**OHIO TURNPIKE AND
INFRASTRUCTURE COMMISSION**

ADDENDUM NO. 1

SERVICE PLAZA RENOVATIONS

**CHANGES TO PLAN DRAWINGS
Sheet Number 6-A4.0, 6-A7.6, 6-8.1, 7-AS1.0 and 7-A8.1**

SP-6 Great Lakes & Towpath

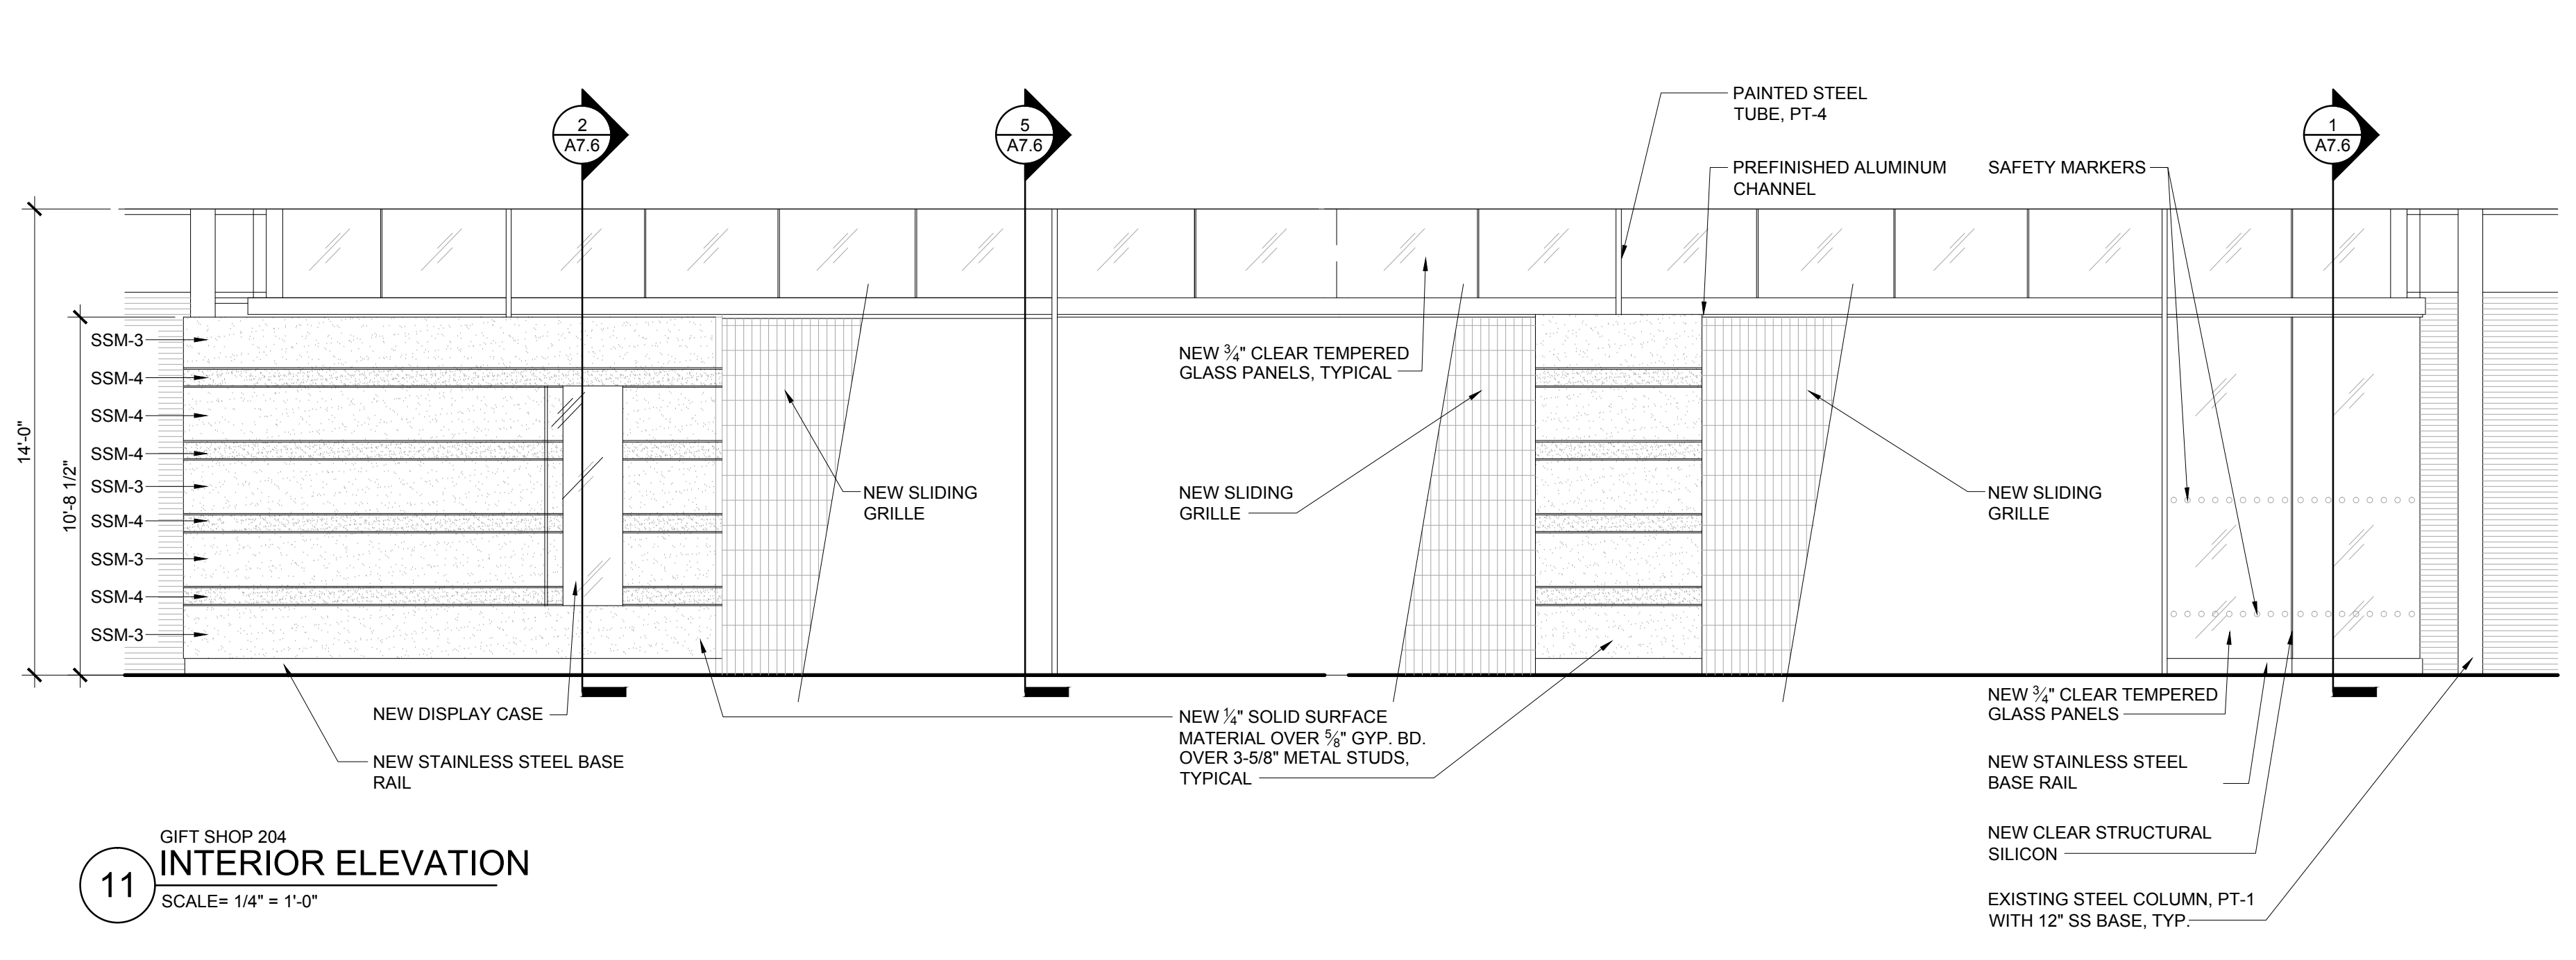
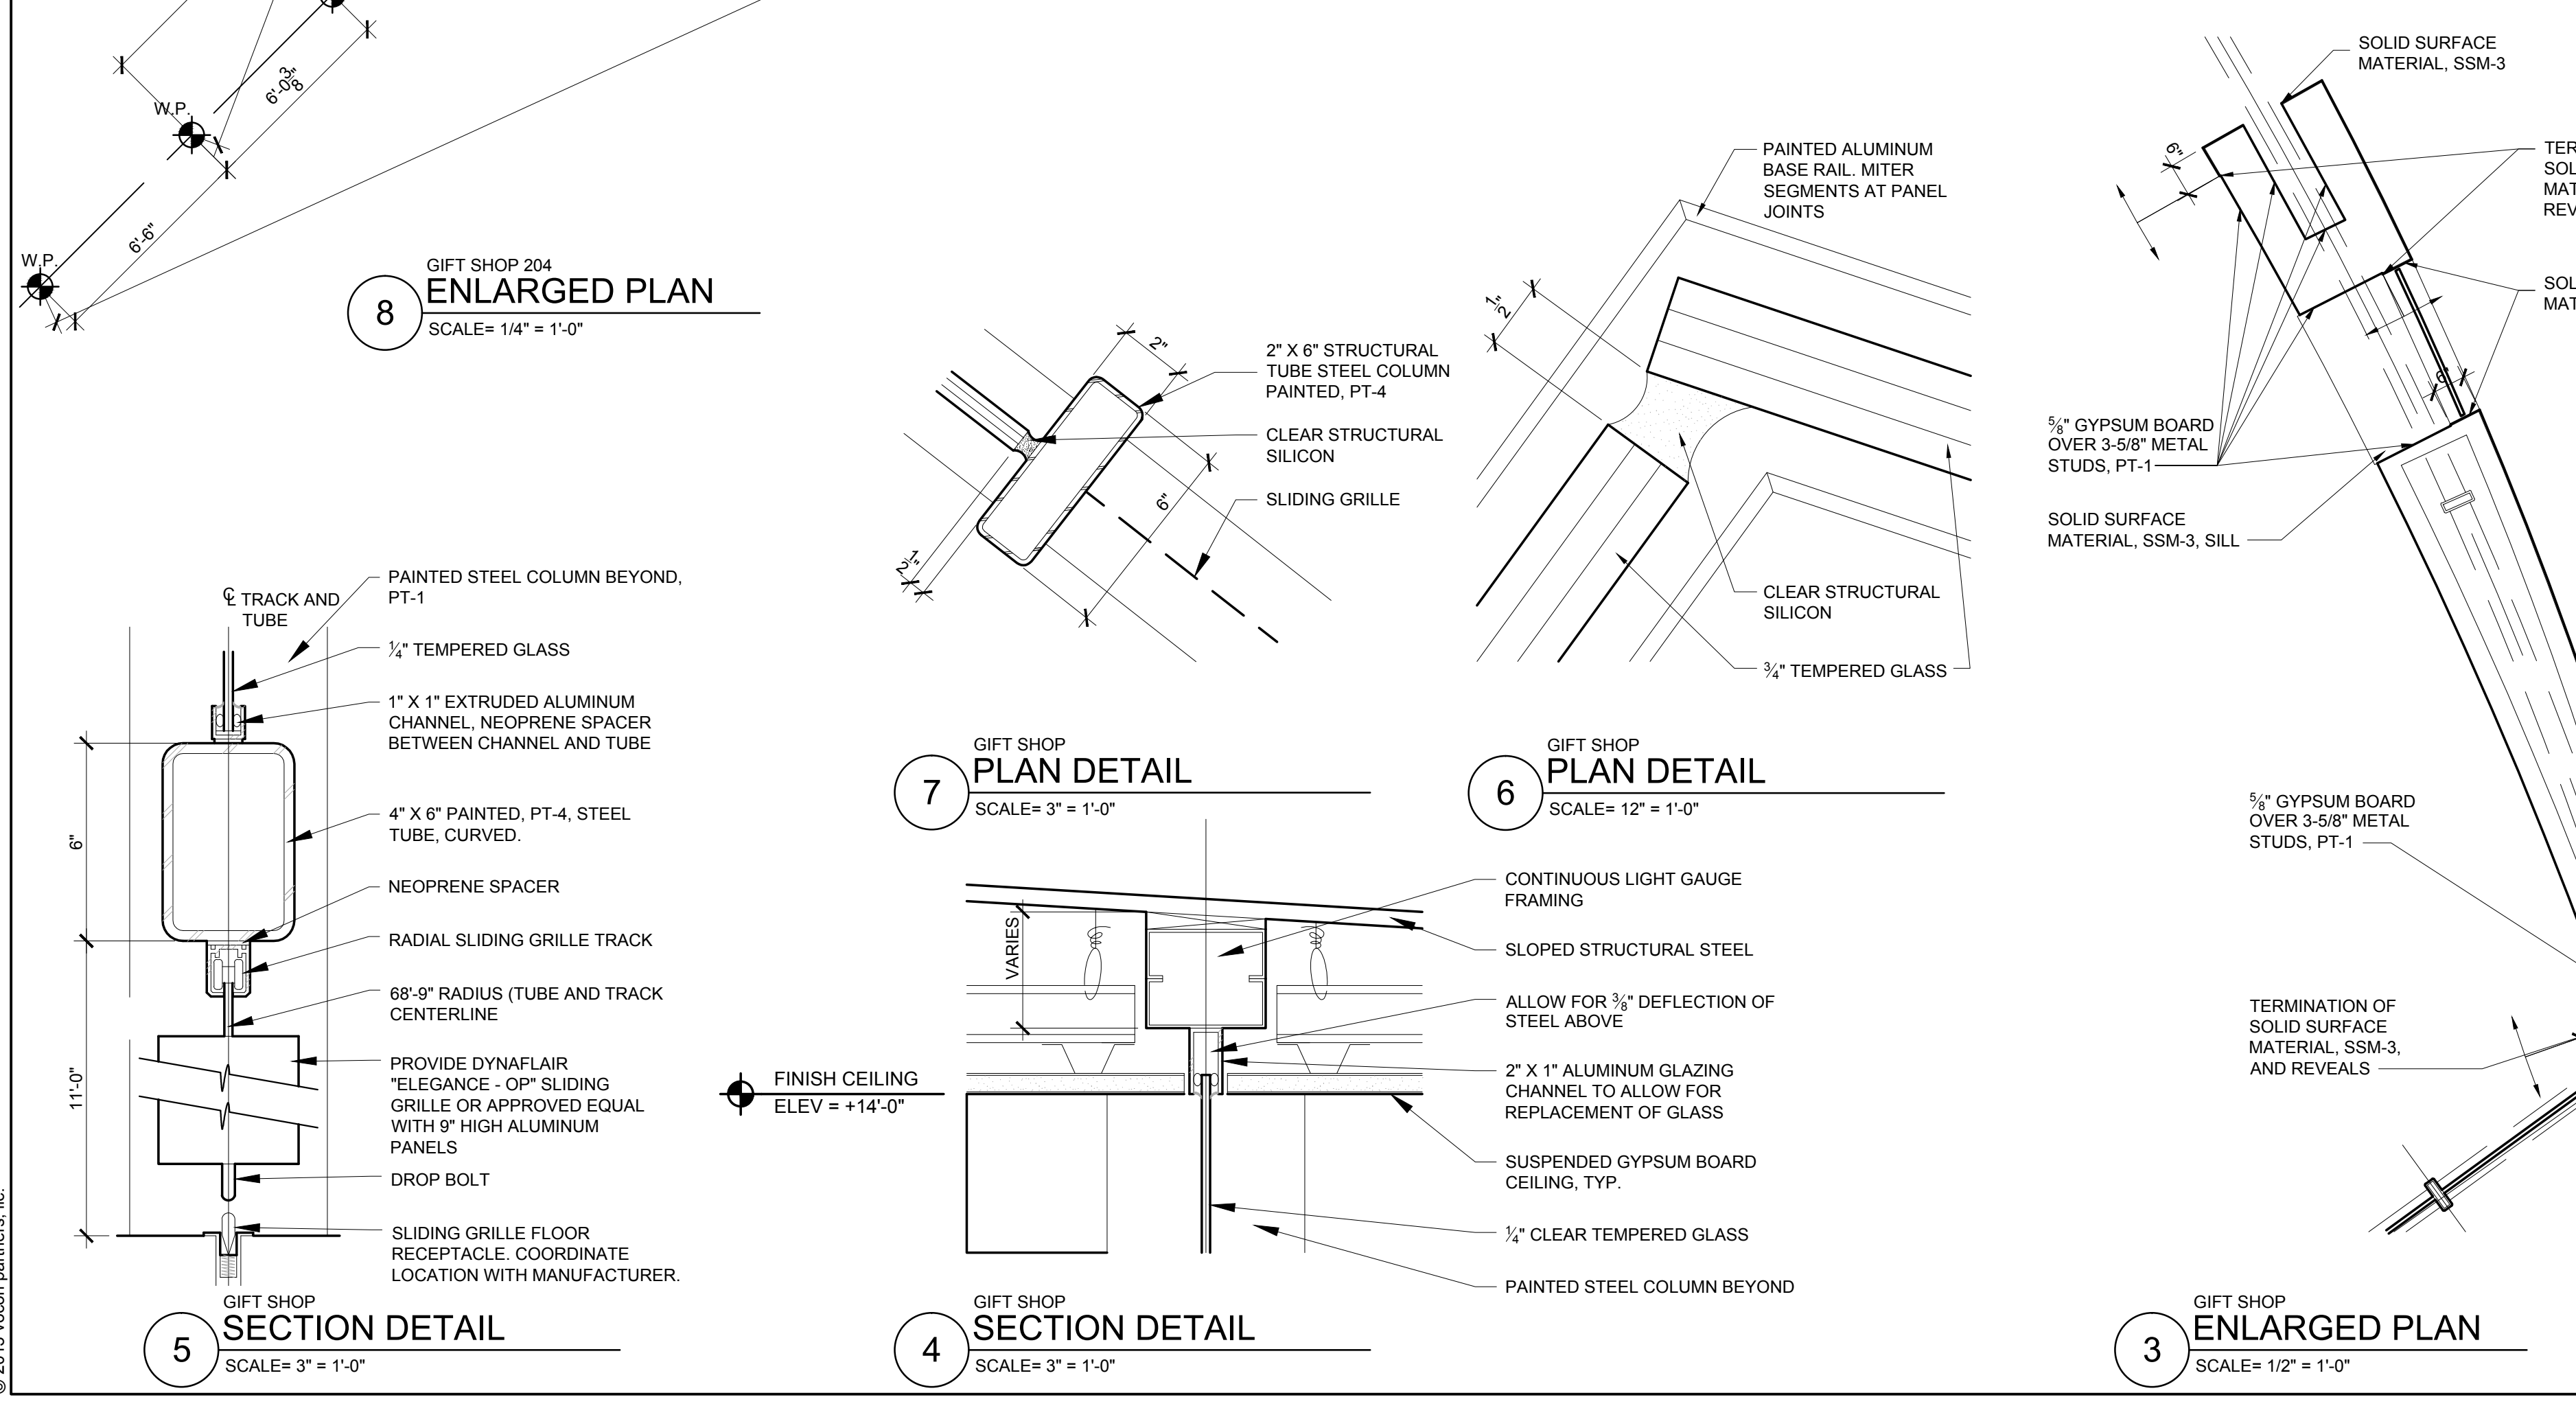
Q#11 Wall section 2 on 6-A7.6 shows a 6"H x 5/8" Dia. stainless steel base and 6"H x 7/8" Dia. stainless steel base. Please clarify what these items are.

A#11 The base dimensions should read 6"H x 5/8" Deep and 6"H x 7/8" Deep. This affects 6.A7.6 Plan Sheet.
